BNC Ref. DA156-23
TCC Ref. MCU25/0011

**RE: APPLICANT RESPONSE TO ASSESSMENT MANAGER INFORMATION REQUEST & FURTHER ADVICE NOTICE
DEVELOPMENT APPLICATION FOR A MATERIAL CHANGE OF USE (ROOMING ACCOMMODATION)
94 BERGIN ROAD, CRANBROOK QLD 4814 (RPD: LOT 1 ON RP737431)**

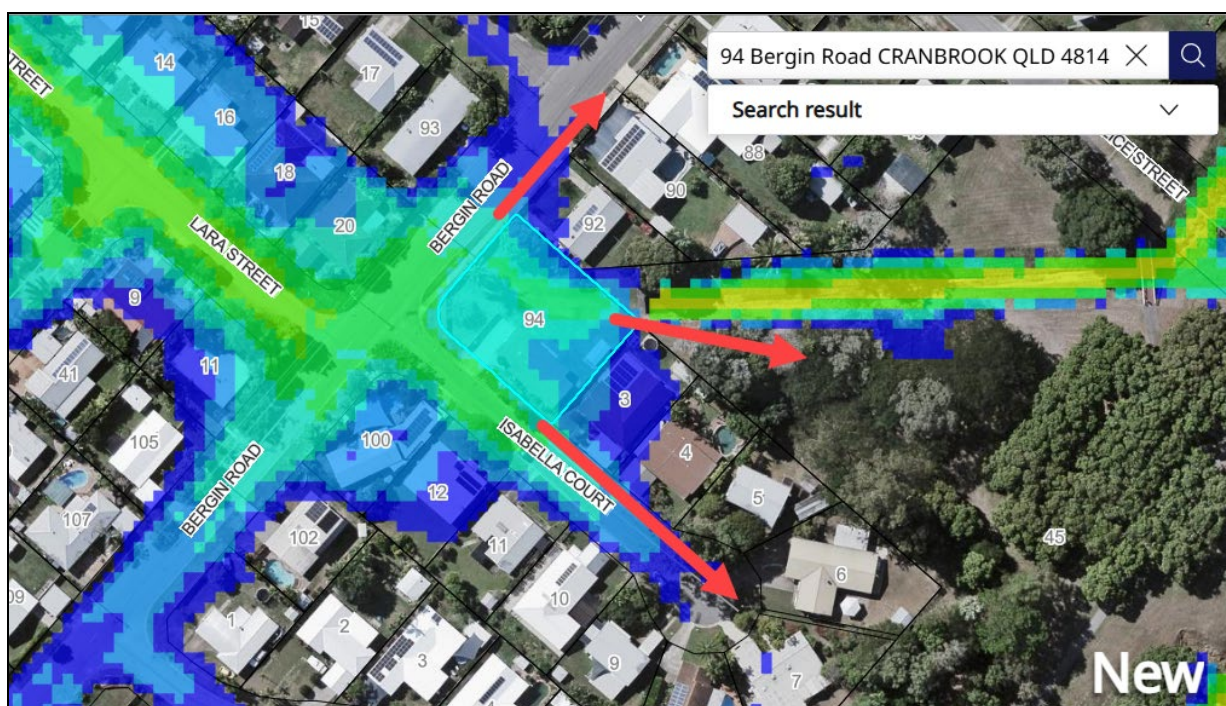
The applicant is advised that the proposed high intensity within the High Flood Hazard area poses an unacceptable level of risk to people or property which will occupy the land and requires further consideration. As per the recent flood model mapping, the development site is mapped as Very High and High Risk with average 1% AEP depth of 0.58m.

The applicant has resolved to reduce the scale of the proposed development which allows for a significant improvement in the ability to manage vulnerability and reduces the risk to people and property from flood hazard to an acceptable/tolerable level. The amended proposal retains the number of rooms but significantly improves the level of vulnerability by replacing ground level floor space with second-storey space and congregating the built form in the lower risk areas of the site. The applicant also provides the attached updated Flood Impact Assessment which undertakes a detailed review of flood risk, both for the dwellings and car park areas, and concludes that the risk is tolerable. Additionally, the applicant offers the attached Emergency Evacuation Plan which outlines a range of operational and behavioral systems that will be put in place as part of managing the rooming accommodation activities. This combined physical and operational mitigation strategies, in conjunction with the design changes made to the building and car park, ensures the risk to people and property is acceptable.

The yet to be adopted new flood risk mapping is acknowledged, as is the updated 1%AEP flood depth data. It is also acknowledged that, under the current planning scheme, the site is mapped across the low, medium and high hazard areas. The attached Flood Impact Assessment reflects this latest data. It is also of significant importance to acknowledge the greater context of the site, specifically the fact that it exists on the fringe of the 1%AEP inundation area, which makes egress and refuge into community land very achievable. Mapping extract below.
